Attachment 3

Mark-ups of Affected Technical Specifications Pages
and Proposed Replacement Curves
for the Request for Revision to the Pressure-
Temperature Curves (PCOL 96/10)
for
Grand Gulf Nuclear Station

GNRO-96/00120

3.4.11

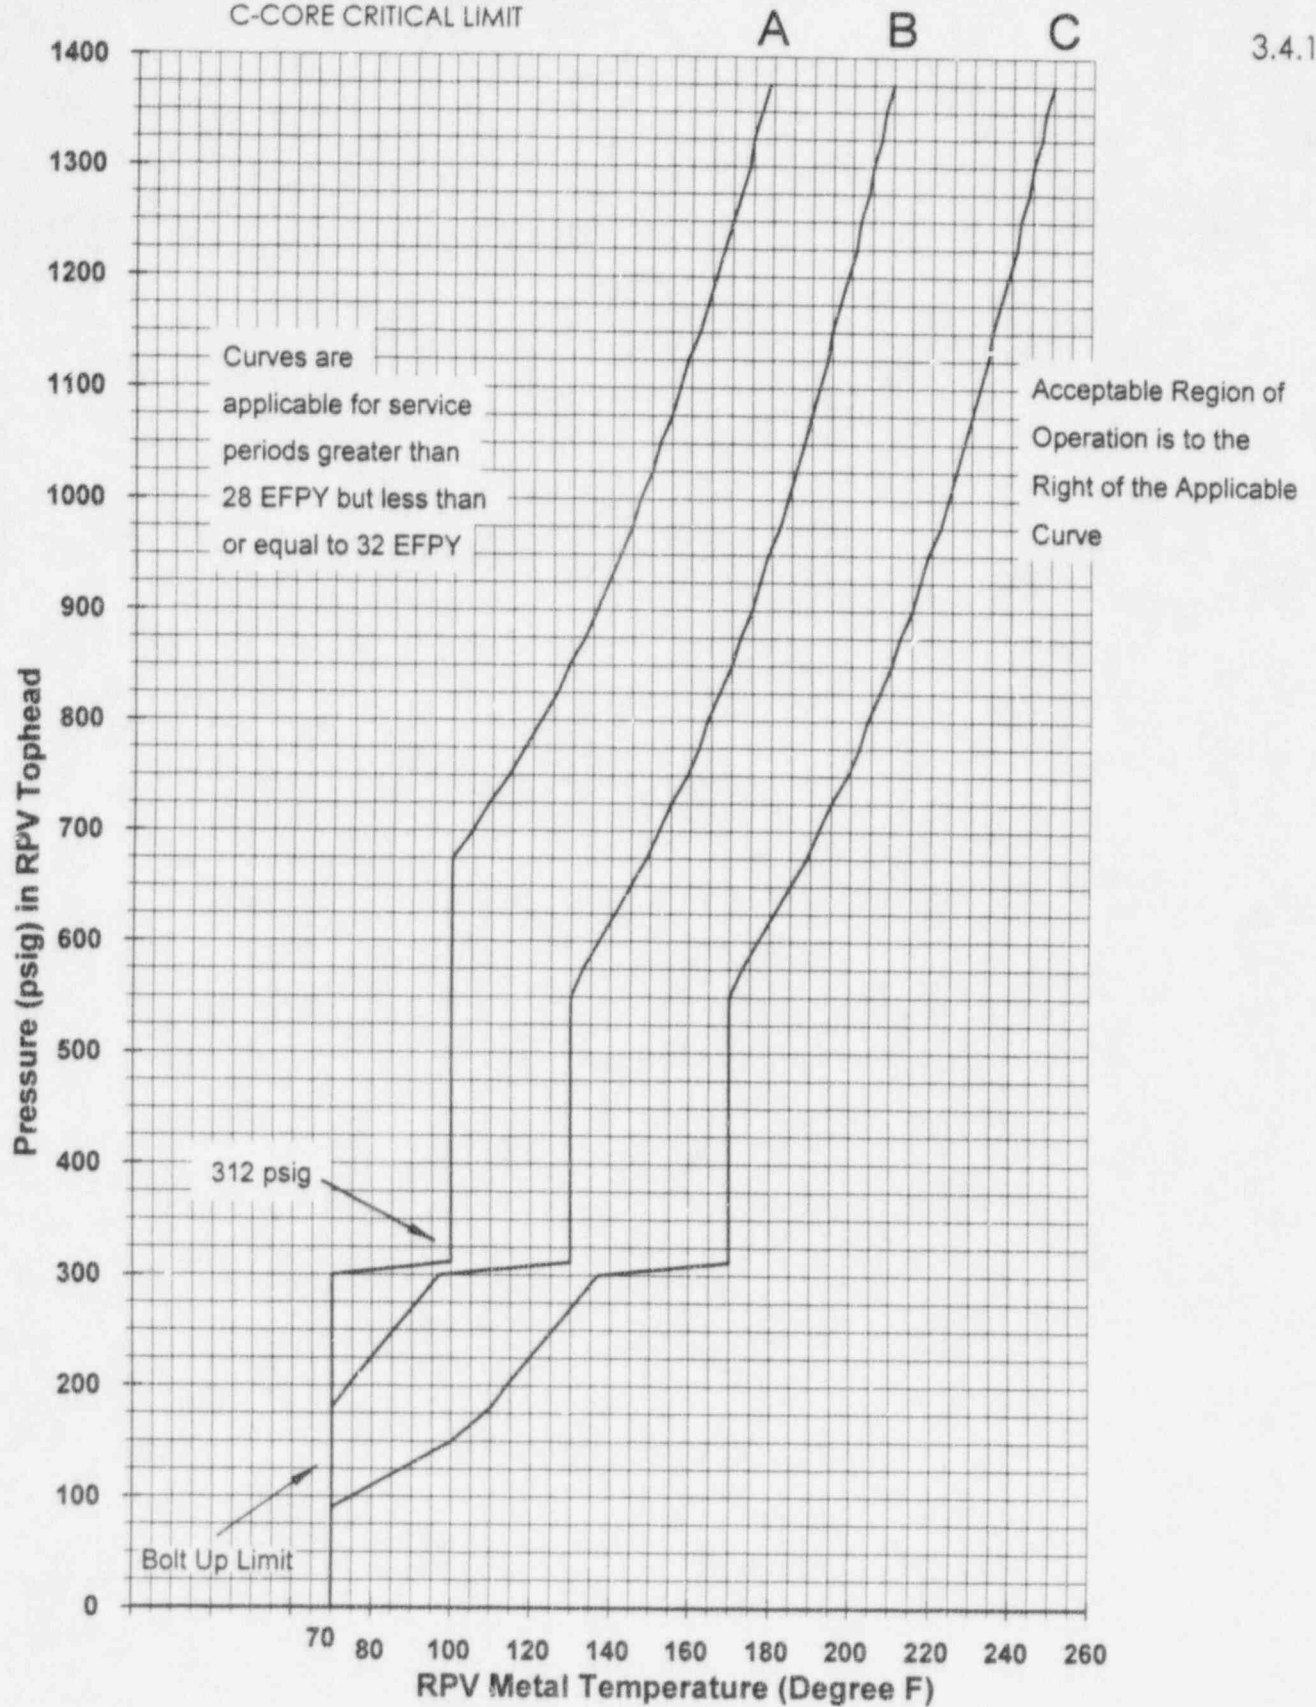
A-INSERVICE LEAK & HYDROSTATIC TESTING LIMIT
B-CORE NOT CRITICAL LIMIT
C-CORE CRITICAL LIMIT
